CITY OF ST. LOUIS
**PLANNING & URBAN
DESIGN AGENCY**
CULTURAL RESOURCES OFFICE
FRANCIS G. SLAY, Mayor

DATE: February 25, 2013
ADDRESS: 1727 Park Avenue
ITEM: Preliminary Review to construct an 8-foot fence
JURISDICTION: Lafayette Square Local Historic District — Ward 6
STAFF: Andrea Gagen, Cultural Resources Office

DATE: February 25, 2013
ADDRESS: 2613 South 13th
ITEM: New Application to construct a staircase and deck on a Semi-Public Façade
JURISDICTION: Soulard Certified Local Historic District — Ward 9
STAFF: Bob Bettis, Cultural Resources Office

DATE: February 25, 2013
ADDRESS: 2720-22 South Jefferson Avenue
ITEM: New Application to retain noncompliant windows installed without a permit
JURISDICTION: Benton Park Certified Local Historic District — Ward 9
STAFF: Bob Bettis, Cultural Resources Office

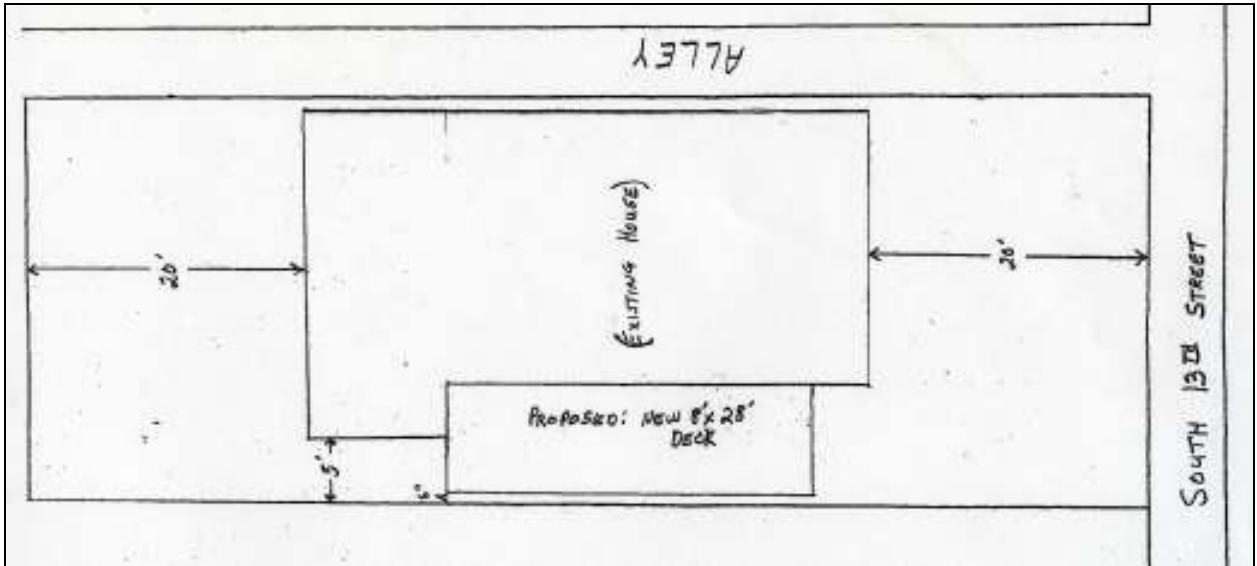
Does not comply. If considered a deck extending nearly the entire length of the Semi-Public Façade, it has the scale to be visually dominant and is not placed at the rear of the building. If considered a side porch, the proposed appendage is not based on a Model Example. The appendage would not meet the standards as either a deck or a side porch.

PROPOSED SITE PLAN

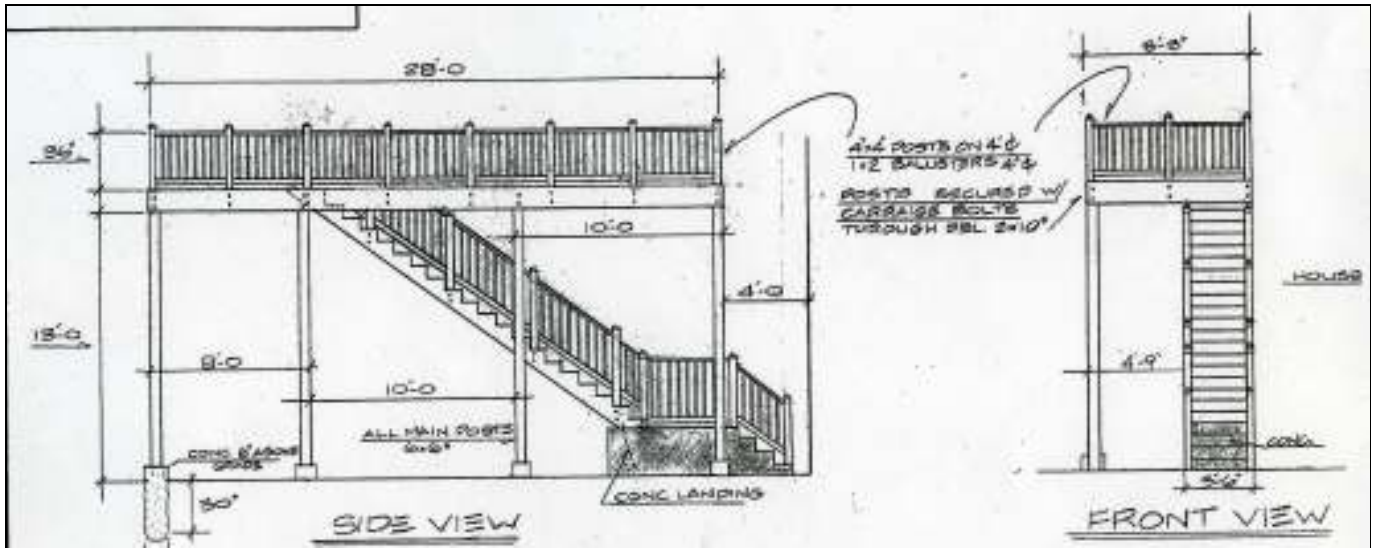
- 2613 South 13th is located in the Soulard Local Historic District;
- The proposed appendage is the entrance to the second-floor living unit and would replace an existing structure and provide more deck space;
- The proposed appendage does not conform to being a two-story porch based on the required Model Example;
- If the proposed appendage with no roof could be considered to be an upper level deck, rather than being placed at the rear of the building, it would be a large scale new feature along nearly the entire Semi-Public Façade; and
- That this proposal, a revision of a design denied by the Cultural Resources Office, keeps the upper level back from the façade of the building, reducing slightly its presence.

PHOTO SHOWING ORIGINAL SEGMENTAL ARCHED BRICKMOLD – EYEBROWS ADDED LATER TO INCORPORATE NEW WINDOWS OR STORMS

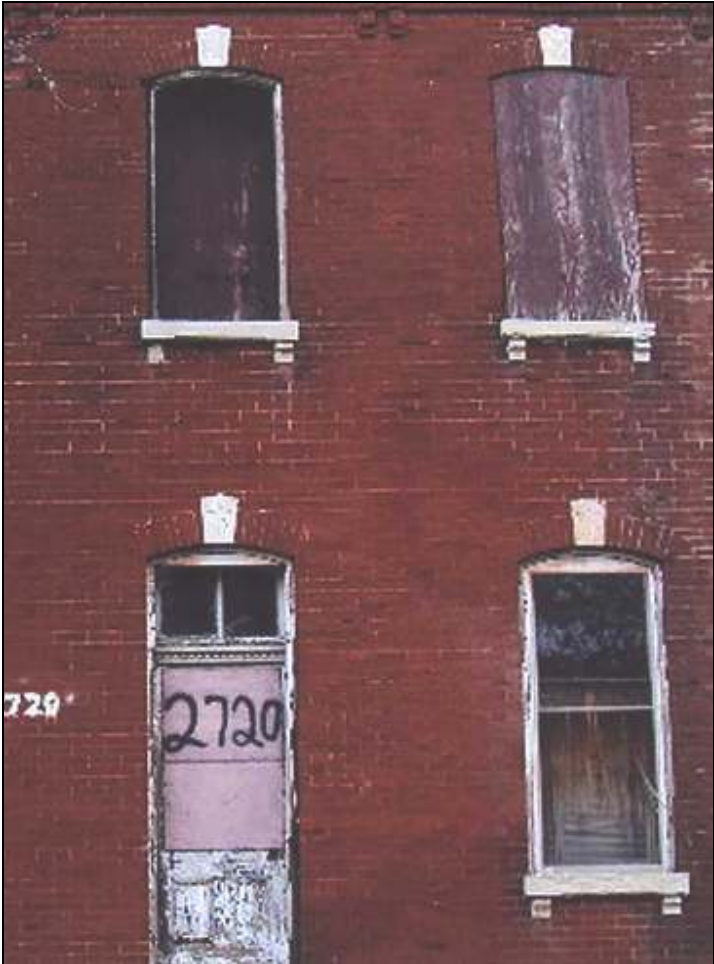
The replacement windows on the Semi-Public façades do not comply, except in that the arched opening may be altered to accommodate rectangular sash under an inserted eyebrow. Like the front windows, they are made of vinyl and do not replicate the original windows. Muntins also are not required to be replicated on a Semi-Public Facade; however, if used, they must replicate the original muntin pattern or be based on a Model Example, and must be pm the exterior. Brickmold on the Semi-Public Façades has been obscured with coil stock.
